SERVICE BULLETIN

Subject: Drive Sprocket – F9T and F9TF Series, Mirage® wheelchair lifts
Applicable Products: Ricon Part Number F9-0450
Effectivity: 01/04/2014

Figure 1 – Primary drive sprocket used on the deploy/stow drive motor

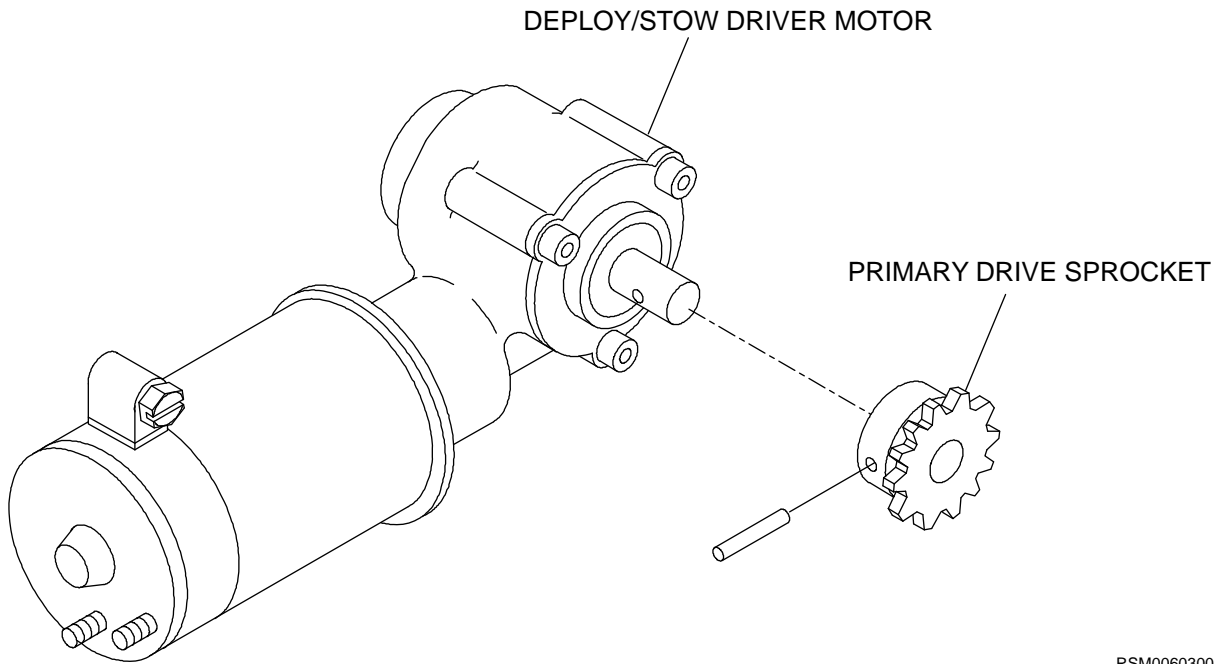
The primary drive sprocket (PN F9-0450) used on the deploy/stow drive motor (see figure 1) in the above referenced range of lifts may fail prematurely causing the motor to spin upon activation of the “Deploy” or “Stow” functions on the hand control but no movement in or out of the lift cassette resulting in the need to manually stow the lift.

Replace the drive sprocket

Figure 2 – Sprocket under-cut too deep

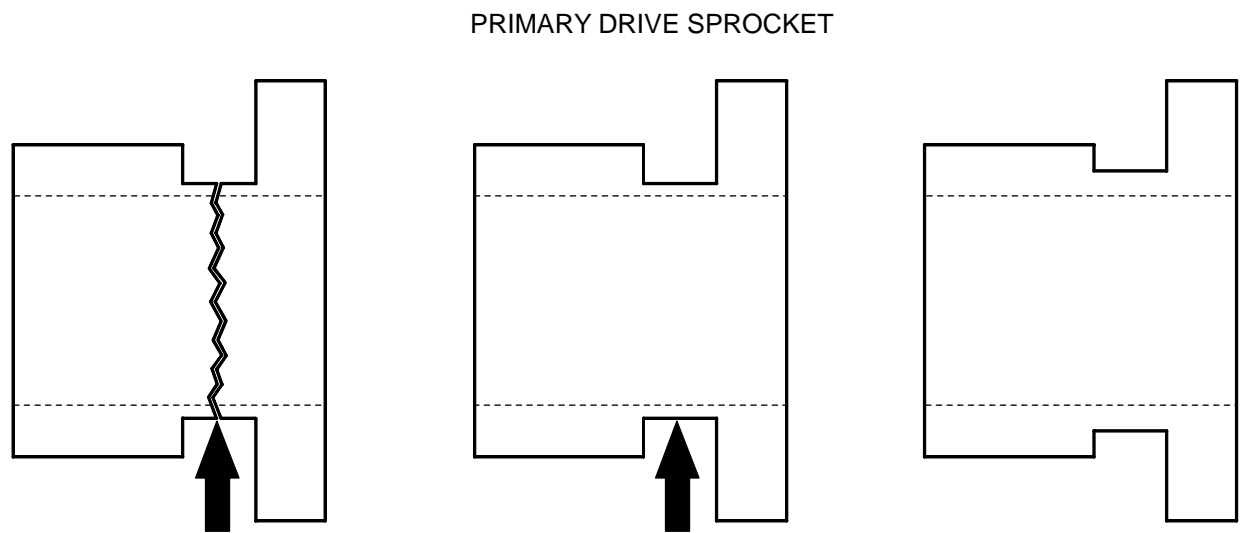
The sprocket PN F9-0450 used in the above referenced range of lifts may have included an under-cut that is deeper than the maximum permitted (see figure 2). In the event the under-cut is too deep, the remaining material available at the cross section may be too thin to support the applied load.
